Project Title: Tuen Mun - Chek Lap Kok Link
工程項目名稱: 屯門至赤鱸角連接路

Construction Sequence of Northern Landfall
北接點施工程序

Drawing Title: **Figure 1.1 Latest Construction Sequence**

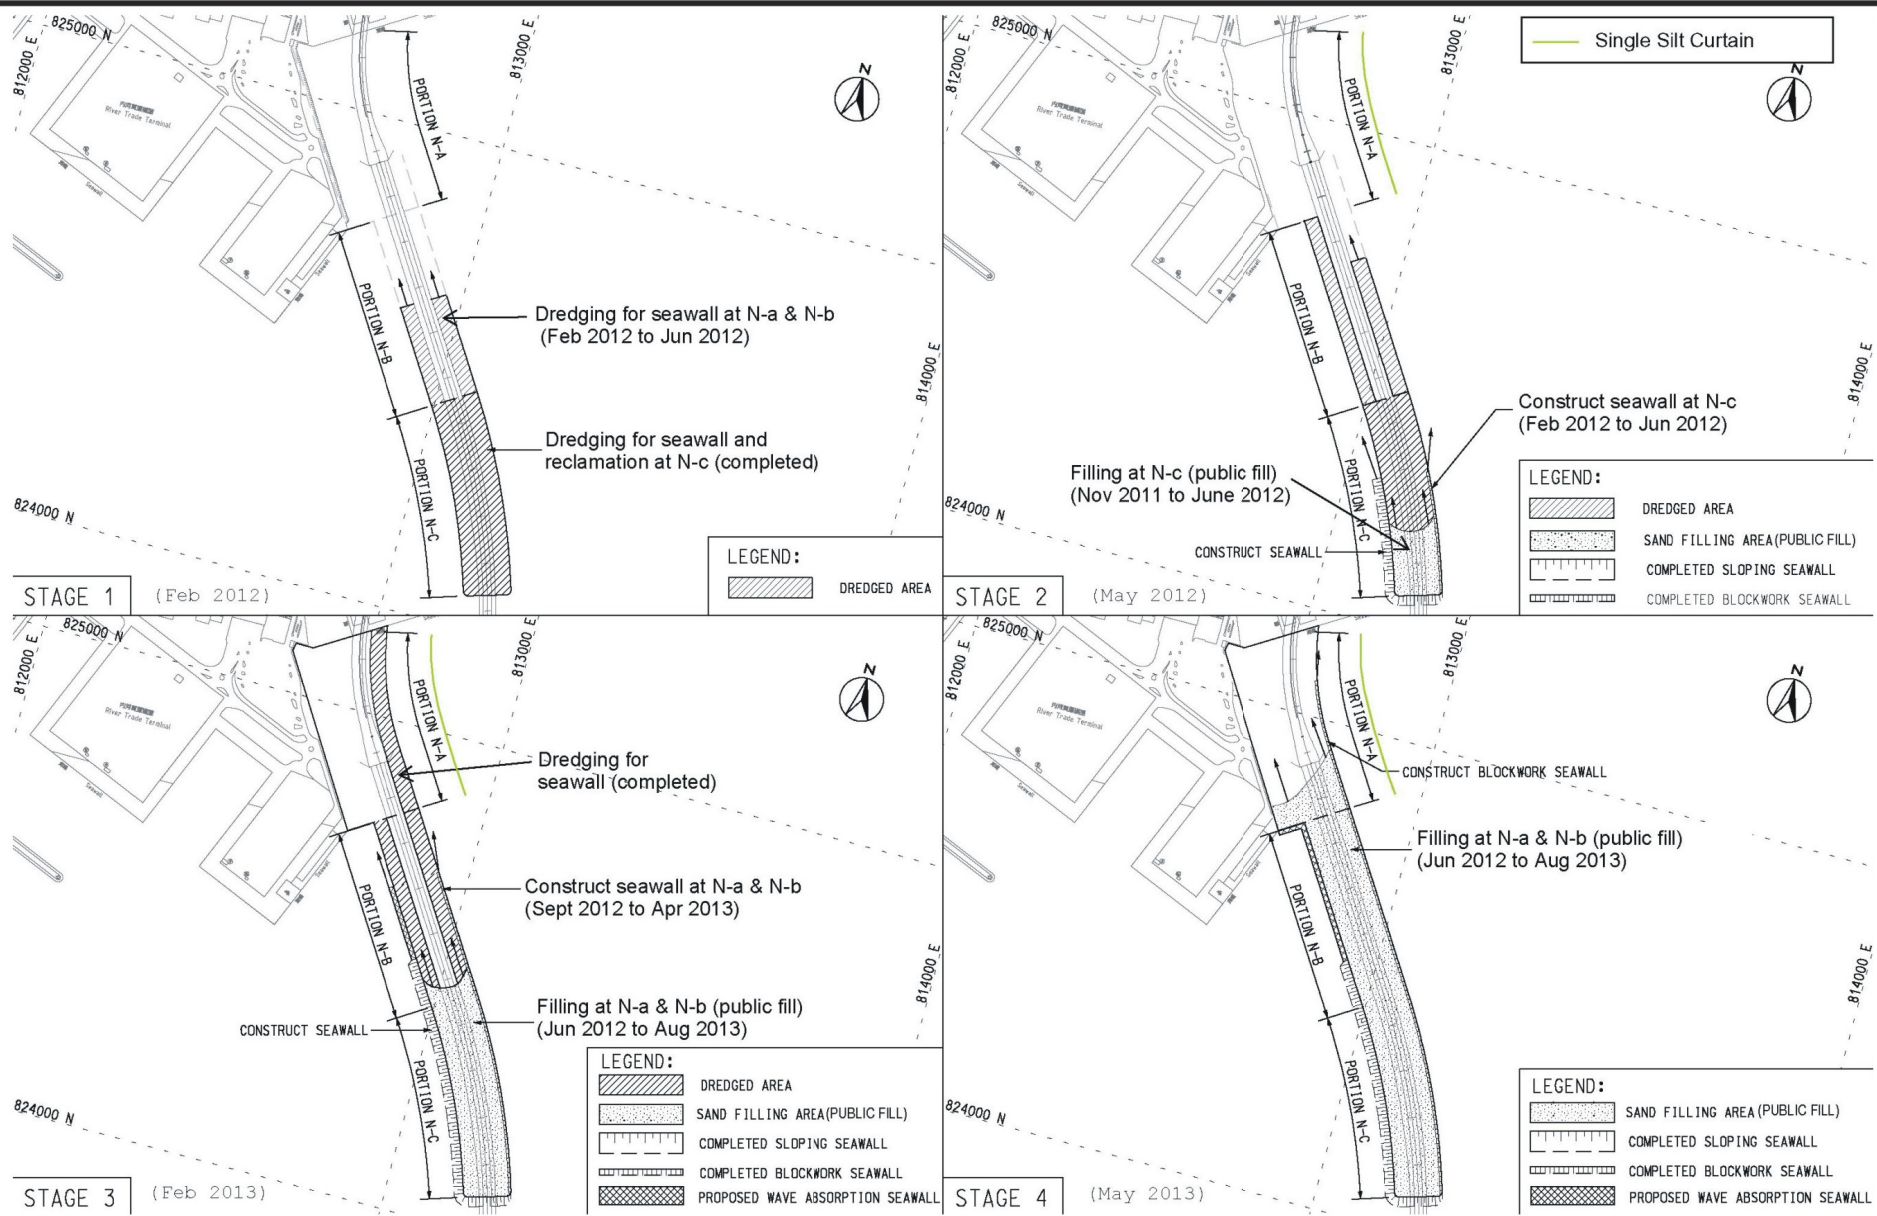
The original construction sequence of the northern landfall reclamation of the Project is illustrated in *Figure 3* of the EP-354/2009A and is attached to this Notification ("the original sequence"). Descriptions of the construction sequence are also provided in *Section 3.2* of the approved EIA Report and are briefly summarised below.

It is assumed in the approved EIA Report that the construction of Portion N-c, the portion of reclamation adjacent to the TBM launching shaft, is critical to the overall programme as the TBM is planned to be launched from the northern reclamation southward (please refer to *Figure 3* of the EP-354/2009A). As such, land is required to be formed earlier for the construction and operation of the launching shaft, as well as for the stockpile of tunnel lining segments, a slurry treatment plant to treat the extracted alluvium arising from the tunnel construction so that it would then be suitable as public fill and other operations. In the approved EIA Report and the EP condition, it is thus assumed that reclamation will commence at Portion N-c, followed by reclamation at Portions N-b and N-a.

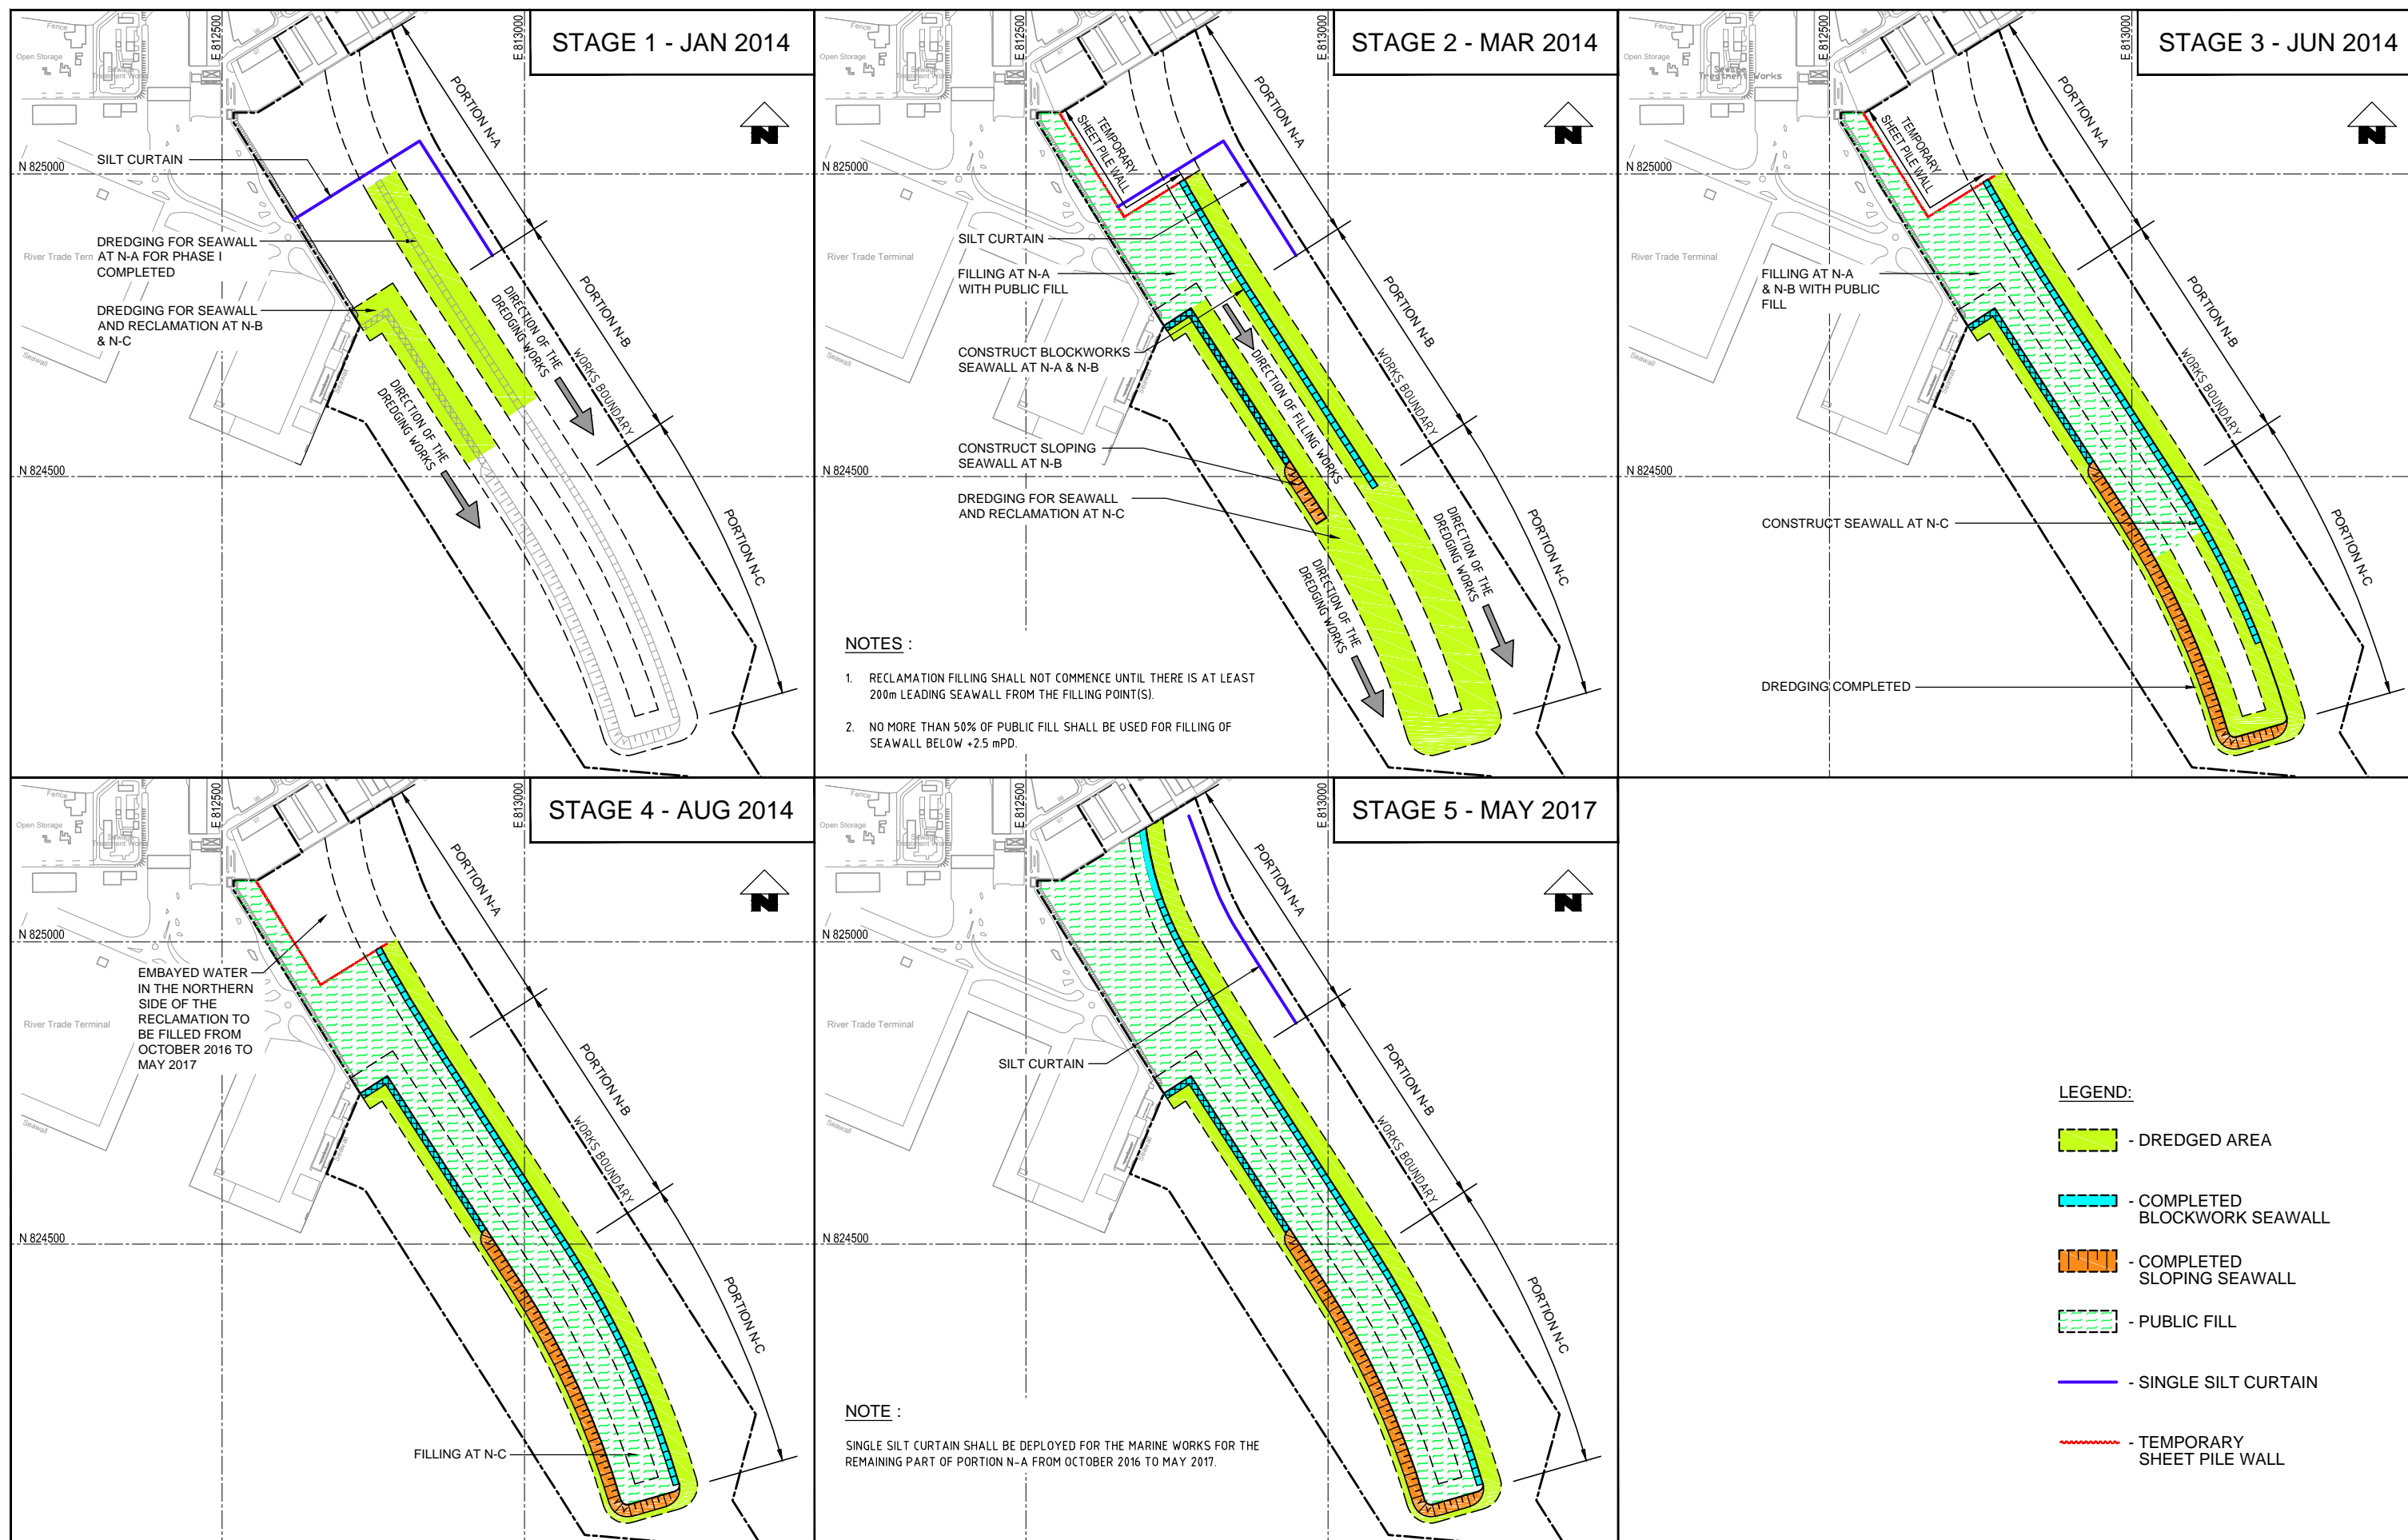
During the detailed design phase of the Contract, the latest development of the tunnels' design requires Portion N-a of the reclamation to be ready first in order to reduce the construction risks. The latest construction sequence is presented in *Figure 1*. Under the latest sequence, it is proposed to commence reclamation at Portion N-a, followed by reclamation at Portions N-b and N-c, which is a reverse of the original sequence of the EIA Report and EP-354/2009A.

- This change of construction sequence will ensure that the reclamation works will always be connected to the shore, avoiding the construction of the reclamation to start with the formation of an island offshore;
- Working from the shore towards the sea will improve the access to the works area (effectively providing a land access) while minimizing the construction risks associated with the strong currents in the works area;
- The access to the works area between the two constructed seawalls (slopping seawall on the western side and vertical seawall on the eastern side) will be done from the open end of the reclamation with reduced impact on the local marine traffic; and
- The works will start in the shallower waters, allowing a better learning process in more protected environment.

Except for the change in the sequence of construction, the construction method (ie plant requirements, duration, method and extent of dredging, filling and seawall construction etc), layout, alignment, scale and design of the Project will be the same between the original and latest construction sequence. In addition, mitigation measures recommended in the EP, approved EIA Report and Environmental Monitoring and Audit Manual of the Project for the original sequence will also be adopted for the construction of the latest sequence. It should, however, be noted that the arrangement of the single silt curtain at Portion N-a will be changed due to concern of marine access to the piers along the northern coast of the Northern Landfall during Stage 1 and Stage 2 of works (*Figure 1*).
